**Z-25
(2017)**

Project title
**Atlanta Road
Site Plan**

PETITION NO: Z-25

ZONING COMMENTS:

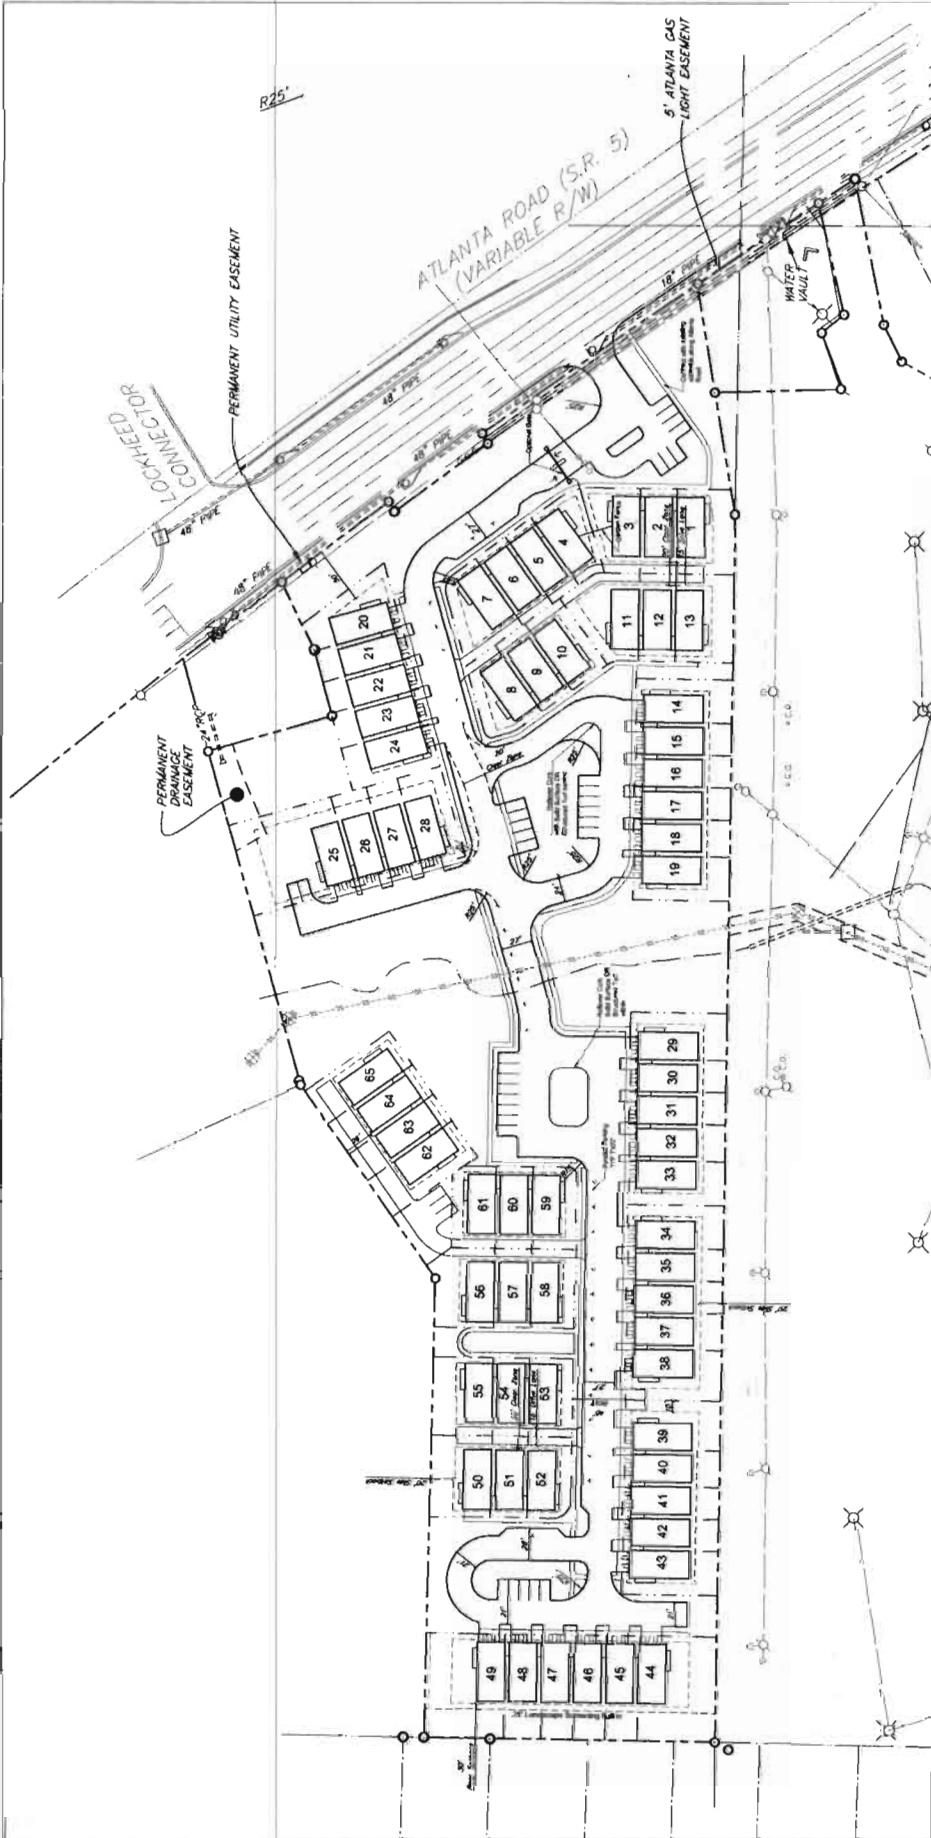
Cobb County Zoning buffers must be fully vegetated across the full width of the buffer. The rear walls of the proposed units along the west property line are approximately 5 feet from the buffer. This may create safety, security, and maintenance issues for the occupants of those units. This will increase the likelihood of encroachments into this buffer. Cobb County staff will be obligated to regulate this buffer in perpetuity, including the mitigation of any buffer violations. Applicant should therefore consider reducing the footprint of the units adjacent to the buffer.

2. The existing stream channel that traverses the center of the site is indicated as a buffered stream on the County's stream buffer map. The required impervious setback will impact the location of units 19, 65 and 85. In addition, stormwater management for the development must also be located outside the undisturbed stream buffer. Unless this is placed underground, additional lots will be impacted by the need for a surface stormwater management facility.

3. Since there is no existing drainage easement or well-defined conveyance through the existing residential parcels within Green Acres Subdivision to the west, all impervious runoff from the western end of the site will need to be directed to the existing stream on the site.
